KWM-380 TRANSCEIVER (622-5093-101)  
HF-380 TRANSCEIVER (622-3580-101)  
RECEIVER-EXCITER CIRCUIT CARD A3 (638-6908-001)

SERVICE BULLETIN NO 1

PRODUCT IMPROVEMENT

P/O Receiver/Exciter Circuit Card A3  
Figure 1

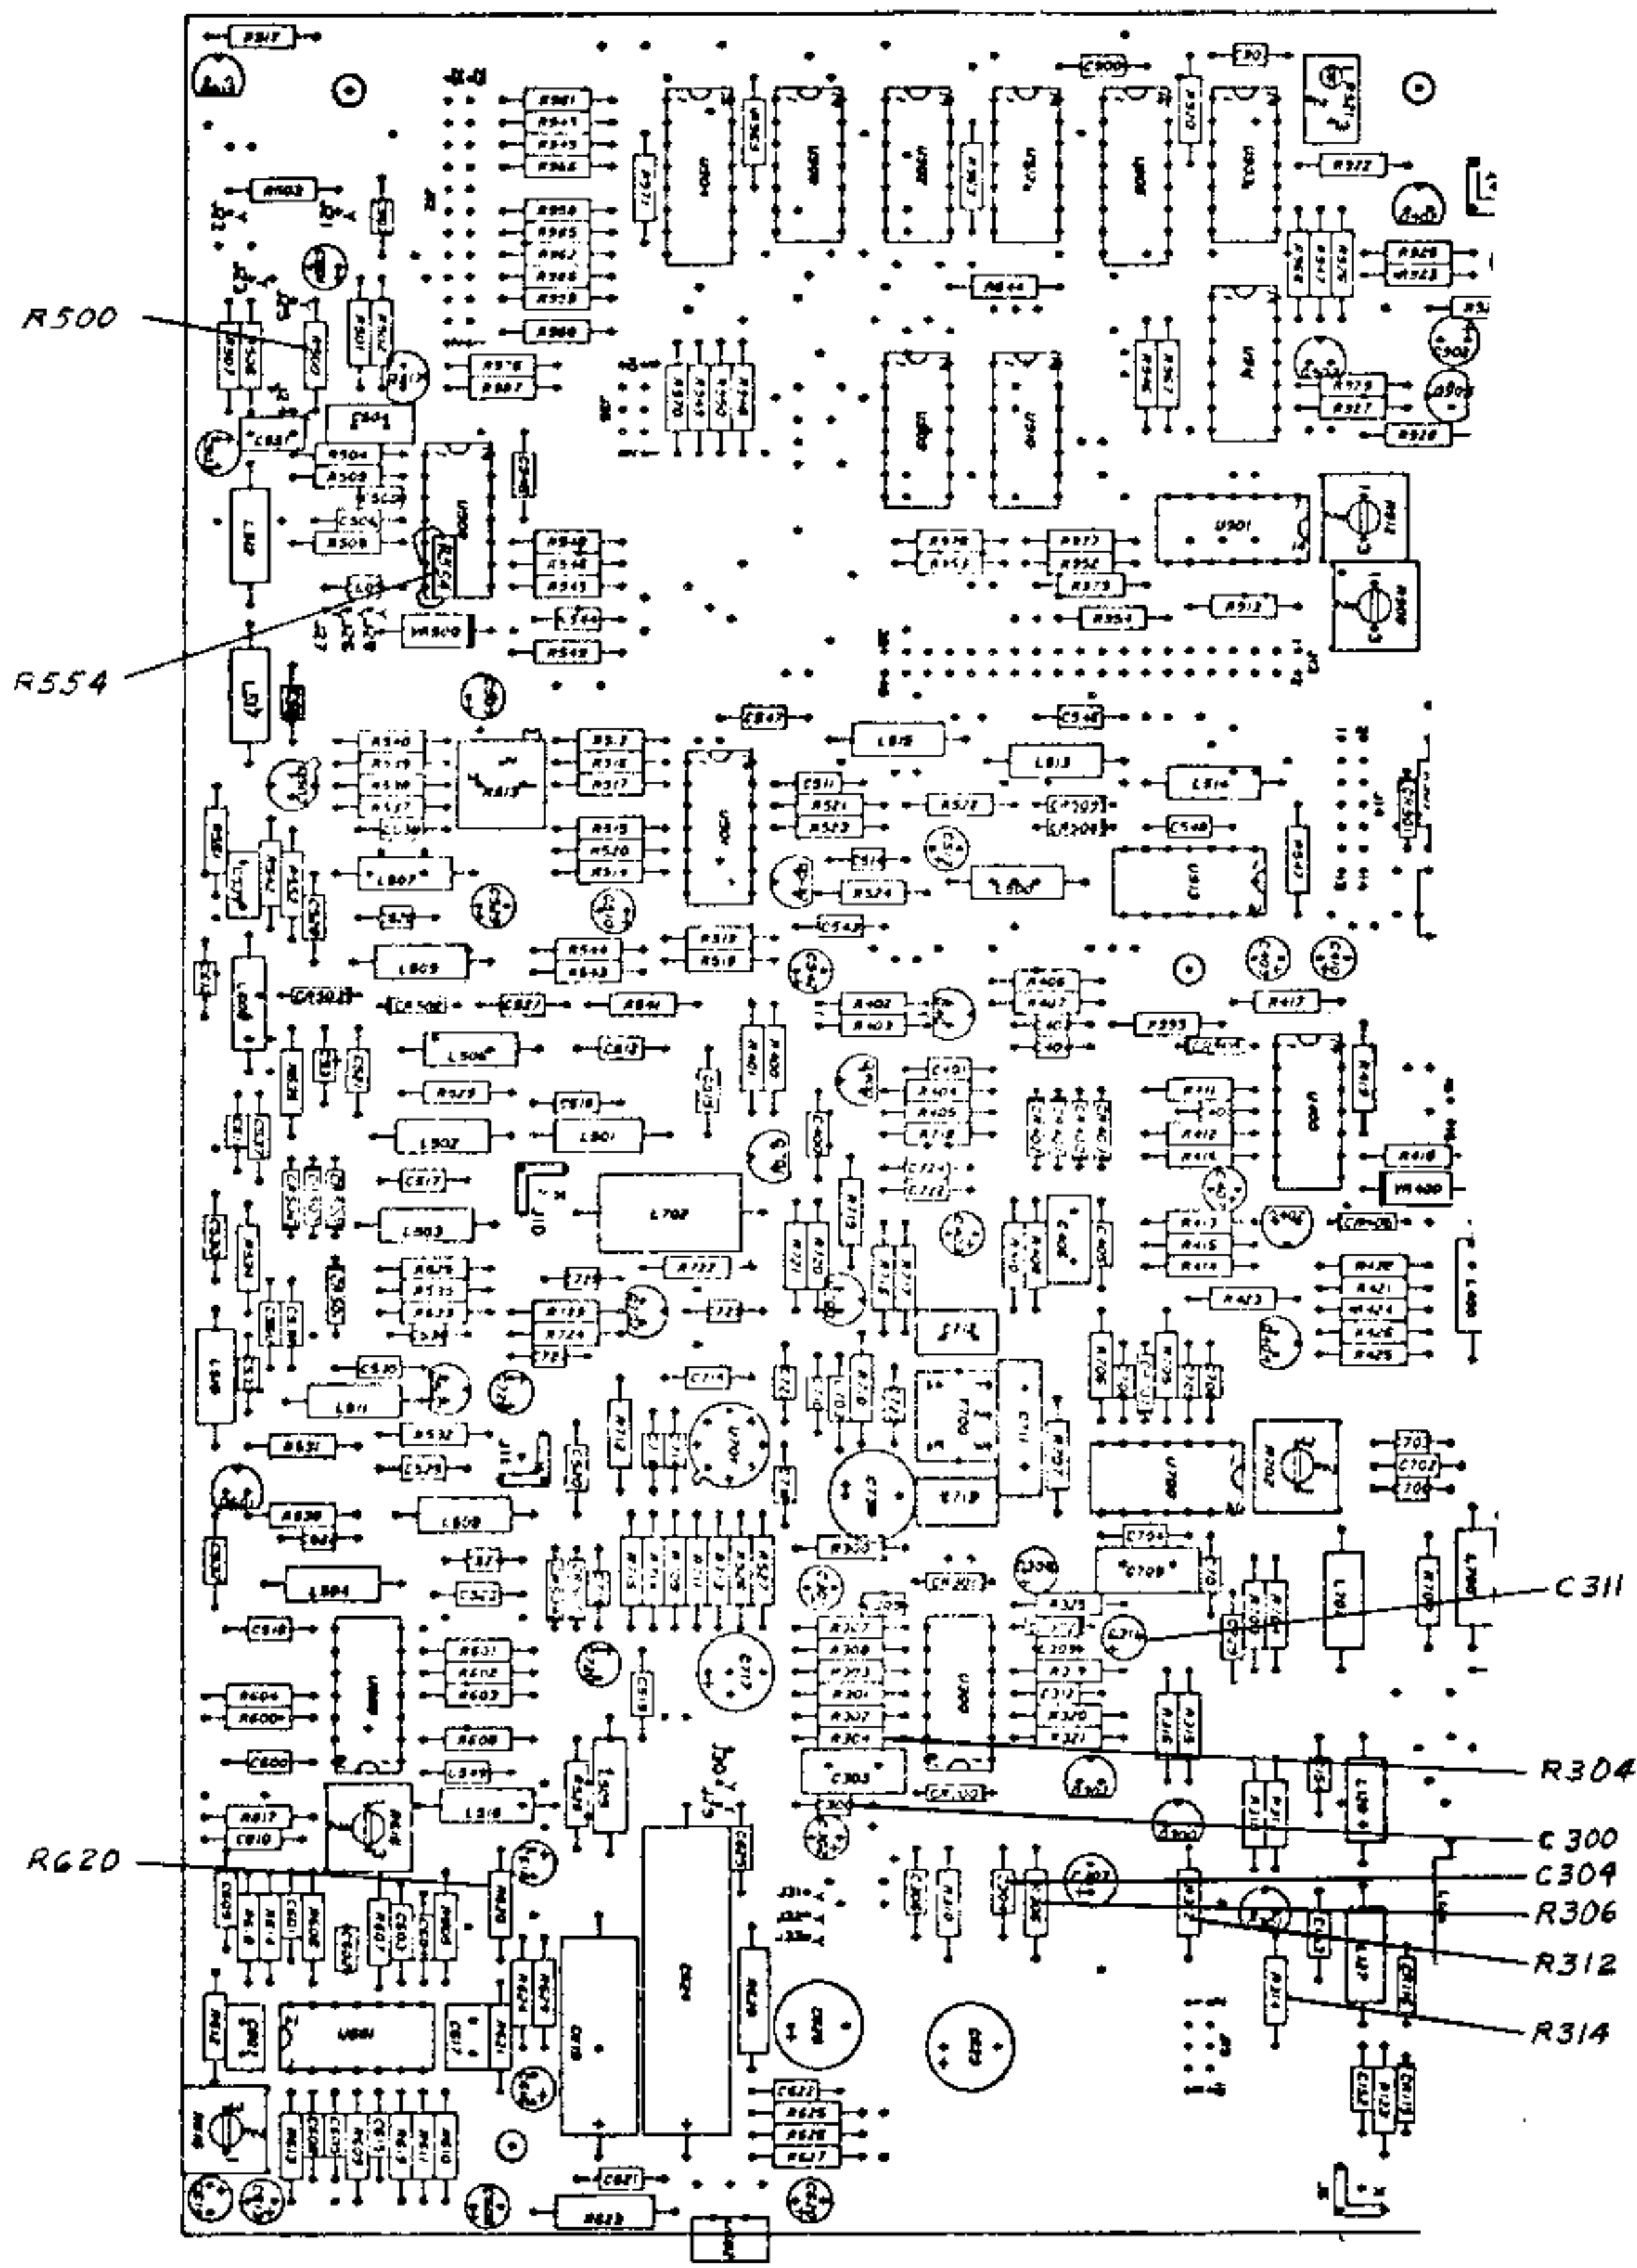
NOTE: All component changes are on the receiver-exciter card A3, located on the bottom of the chassis. Refer to figure 1 for location of components on the receiver-exciter card.

- C. Remove 100-k  $\Omega$  resistor R554 and replace it with a 1-M  $\Omega$  resistor (745-2449-000).
- D. Remove 270-  $\Omega$  resistor R500 and replace it with a 3.3-k  $\Omega$  resistor (745-0767-000).

- E. Remove 33-k  $\Omega$  resistor R620 and replace it with an 18-k  $\Omega$  resistor (745-0794-000).
- F. Remove 1- $\mu$ F capacitor C311 and replace it with a 0.22- $\mu$ F capacitor (184-9102-310).

- G. Remove 1-M  $\Omega$  resistor R304 and replace it with a 100-k  $\Omega$  resistor (745-0821-000).
- H. Remove 0.01- $\mu$ F capacitor C300 and replace it with a 1000-pF capacitor (913-3281-270).

- I. Remove 0.1- $\mu$ F capacitor C304 and replace it with a 4.7- $\mu$ F capacitor (184-9102-390). The negative lead of the capacitor should be connected to the hole on the left.

- J. Remove 1-k  $\Omega$  resistor R306 and replace it with a 100-  $\Omega$  resistor (745-0713-000).
- K. Remove 47-k  $\Omega$  resistors R312 and R314 and replace them with 10-k  $\Omega$  resistors (745-0785-000).

P/O Synthesizer Card A5A1 (638-6916-002)  
Figure 2

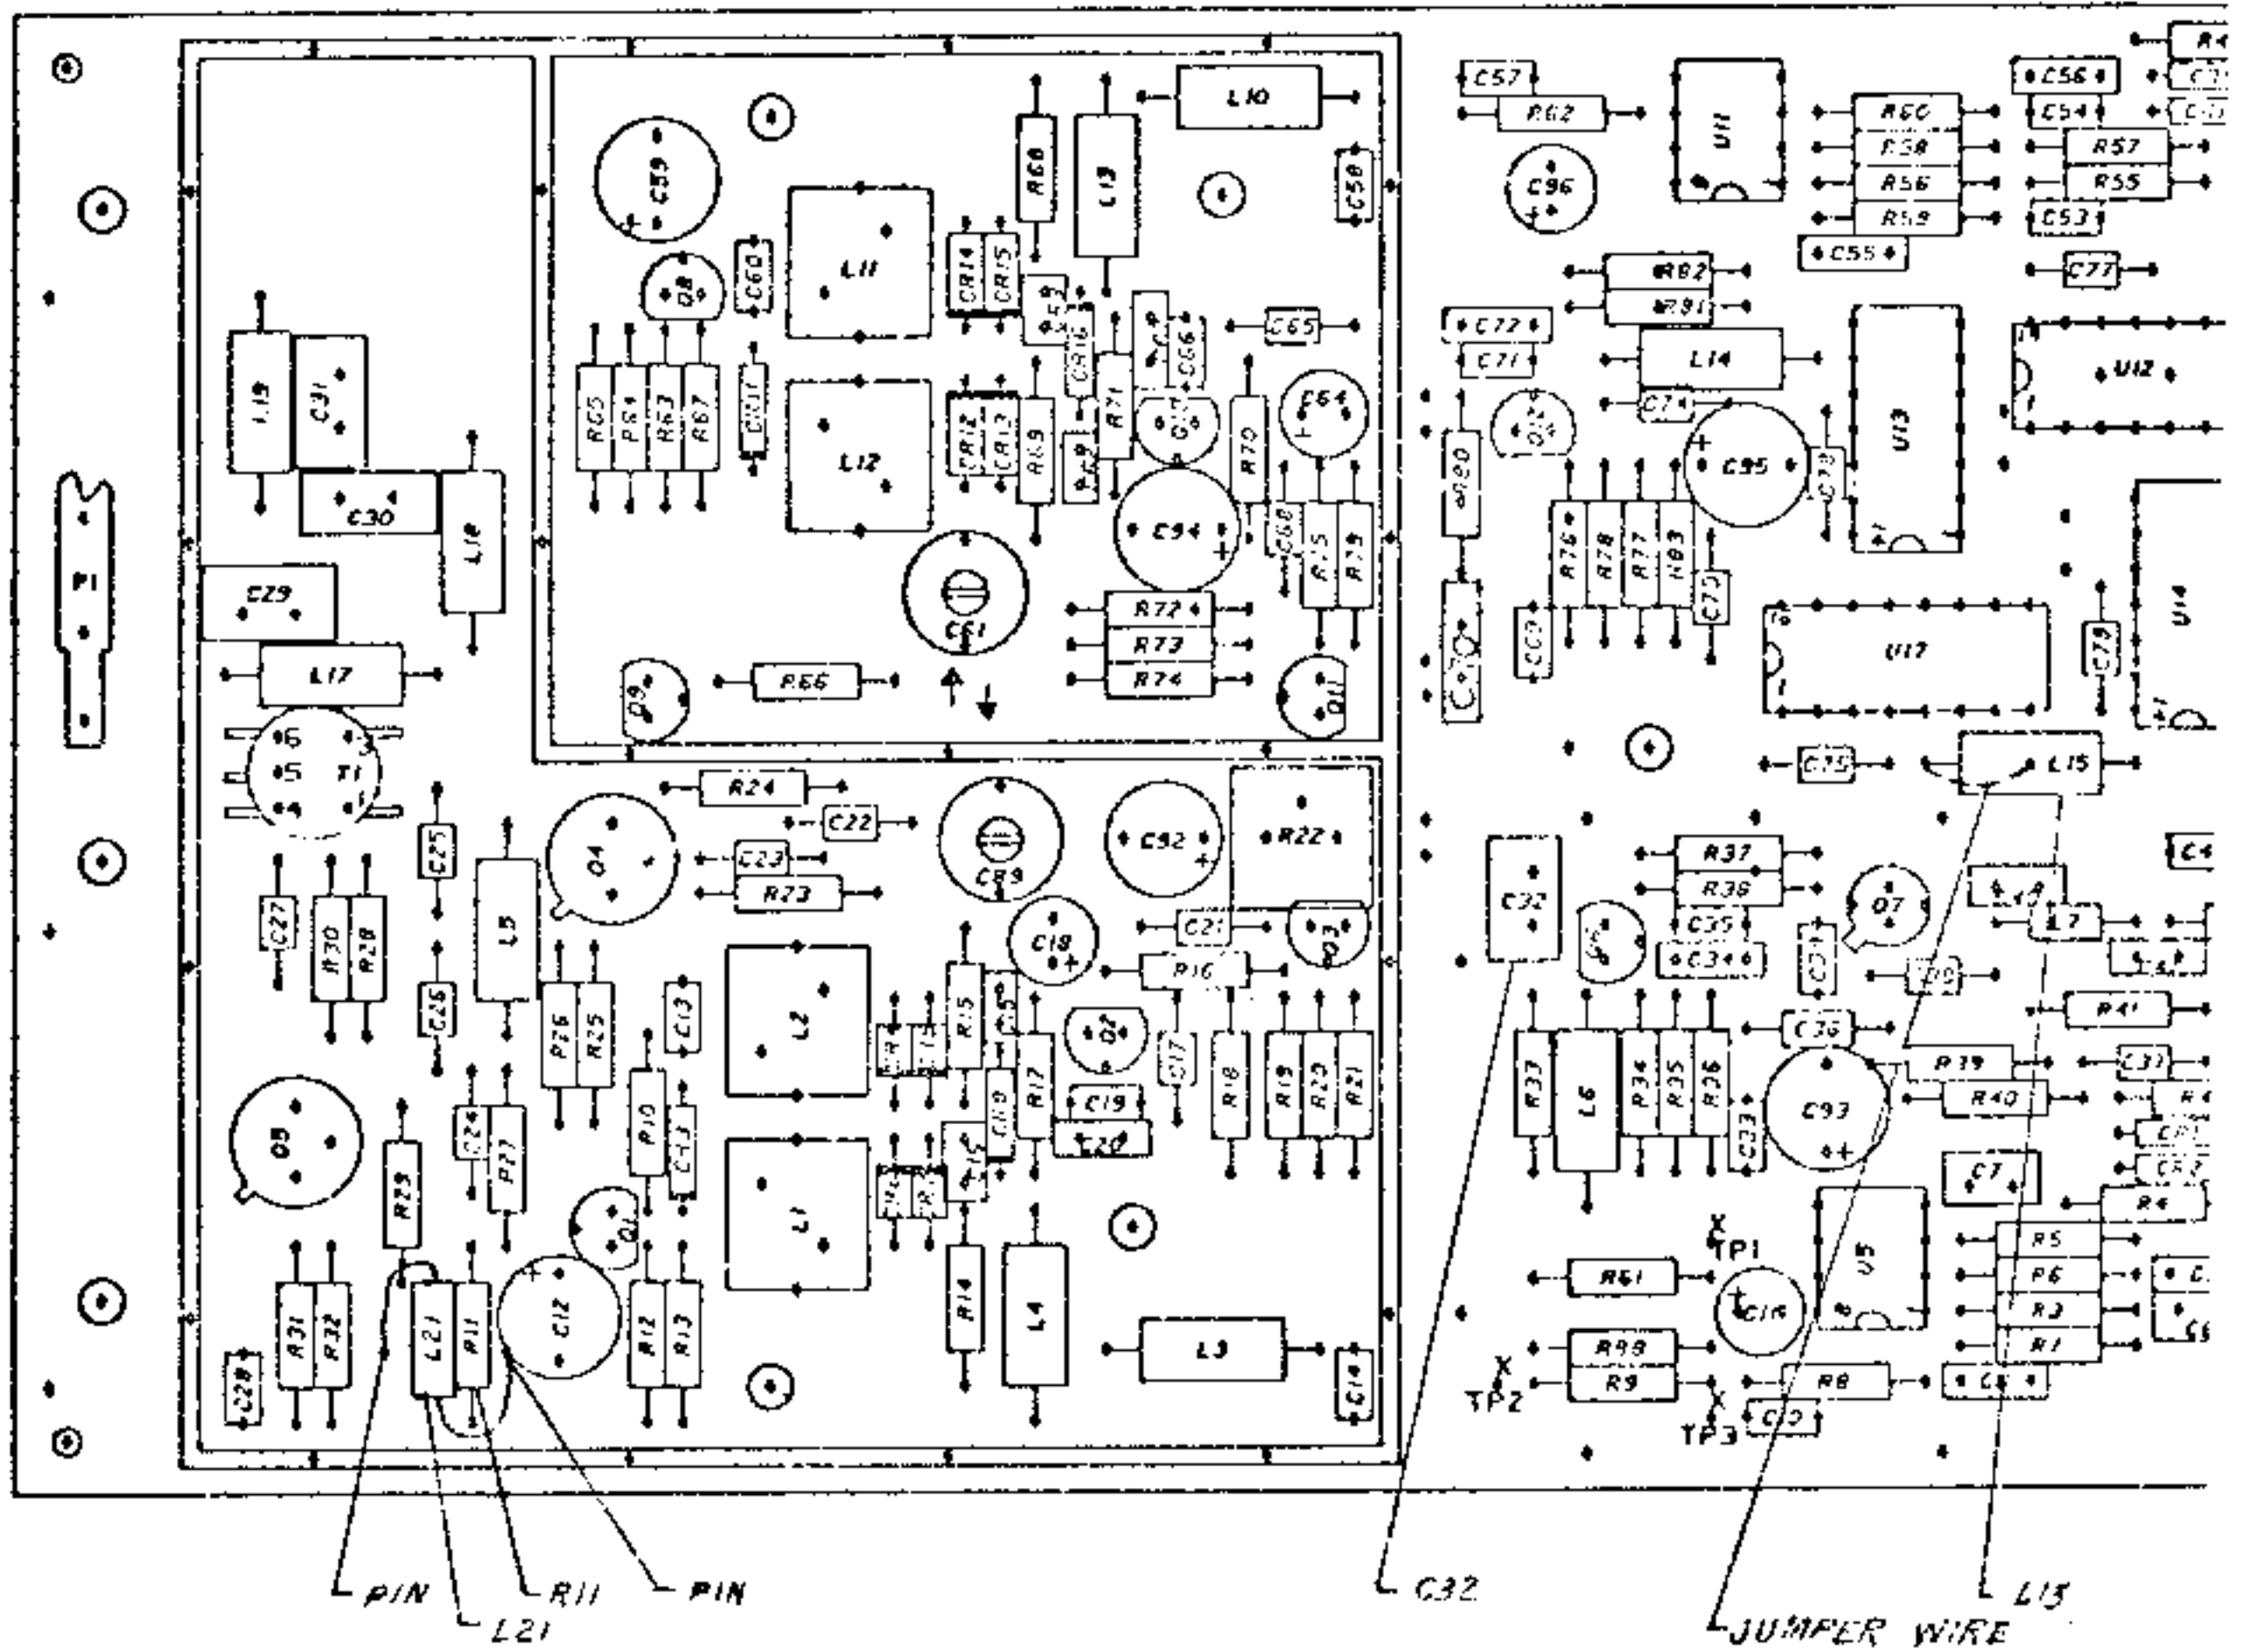
NOTE: All changes are made on synthesizer card A5A1. Refer to figures 1 and 2 for location of components.
- D. Remove the shield cover from A5A1 card (638-6916-001, -002) by removing 19 screws.

- E. Remove A5A1 from A5 assembly by removing seven screws.
- F. On the top of A5A1, cut circuit trace at right lead of coil L15.
- G. On top of card, cut circuit trace located between thru holes where two new pins are shown in figures 1 and 2.

- J. Remove the 27-pF capacitor C32 and replace it with an 18-pF capacitor (913-1098-030).
- K. On the bottom of the card, install a jumper wire (428-0282-050) from the left lead of L15 to the thru hole located under L15.
